APPLICATION NO.	FILING DATE	FIRST NAMED INVENTOR	ATTORNEY DOCKET NO.	CONFIRMATION NO.
10/709,687	05/22/2004	Eduard Torrents Gavalda	8158ES	3686

Office Action Summary	Application No. 10/709,687	Applicant(s) TORRENTS GAVALDA ET AL.	
	Examiner Adi Amrany	Art Unit 2836

DETAILED ACTION

Fig. 2

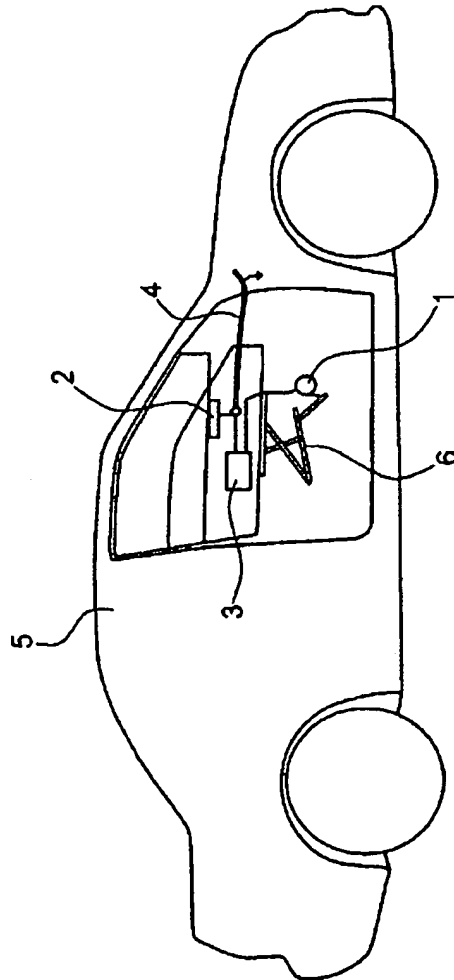
2. A new sheet of drawings (page 2) was received on July 4, 2006. These drawings are acceptable and have been entered into the application.
